Access Compliance Report

Public Rights-of-Way

Intersection ID: 51618	Main Street: SUMMERFORD_DR	Cross Street: PROSPERITY_CHURCH_RD	Location: NW
ADA ID: 06E861E1AECA	Ramp Type: BlendTrans1	Initial Pass/Fail: Pass	Overall Compliance: No
Severity Score: 0.25			
Codes/Mitigation Info/Possible Solution		Field Measurements/Component Compliance

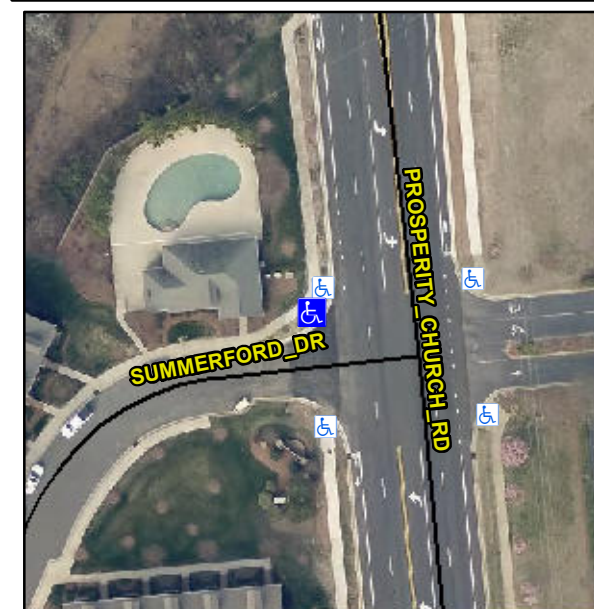
Not Found, R304.5.3, R304.2.2-Perp, R304.3.2-Para, R305.2

Compliance	Description	Data	Compliance	Description	Data
N/A	Ramp Length (in)	34.0	Yes	BlendTrans Slope (%)	1.1
Yes	Ramp Width (in)	73.0	No	BlendTrans XSlope (%)	3.8
Yes	Flare Type L C urbed_NoWalkSurface		Yes	Flare Type R C urbed_NoWalkSurface	
N/A	Flare Slope LT (%)	N/A	N/A	Flare Slope RT (%)	N/A
N/A	Flare Traversable LT?	No	N/A	Flare Traversable RT?	No
Yes	Landing Length (in)	54.0	Yes	DWS Provided?	Yes
Yes	Landing Width (in)	74.0	Yes	DWS Contrast?	Yes
No	Landing Slope (%)	2.2	Yes	DWS Length (in)	24.5
Yes	Landing X Slope (%)	1.7	Yes	DWS Full Width?	Yes
N/A	Landing Curb? (Y/N)	No	No	DWS Offset (in)	7.0
N/A	Shared Landing?	No			
Yes	Gutter Ponding?	No	Yes	Gutter Slope (%)	1.5
Yes	Gutter Lip Ht (in)	0.0	No	Gutter X Slope (%)	2.3
N/A	Painted X Walk1?	No	N/A	Painted X Walk2?	No
	X Walk 1 Direction	To S		X Walk 2 Direction	To E
	X Walk 1 Width (in)	N/A		X Walk 2 Width (in)	N/A
	X Walk 1 Slope (%)	5.8		X Walk 2 Slope (%)	3.3

X Walk 1 X Slope (%)	2.1		X Walk 2 X Slope (%)	7.3
N/A	Ramp inside XWalk1?	N/A	N/A	Ramp inside XWalk2?	N/A
	Road Slope (%)	2.0		Clear Space?	Yes
	Road X Slope (%)	3.7	N/A	Clear Space to XWalk (in)	N/A
Yes	Any Obstructions?	No	Yes	Storm Grate/Utility Hazard?	No
	Obstruction Type			Storm Grate/Utility Type	
		N/A			N/A
			Yes	Surface Condition? (G/P)	Good
			No	Curb Slope (%)	21.8

Remove & Replace Curb Ramp With Two New Directional Ramps or Equivalent. Remove & Replace Gutter.
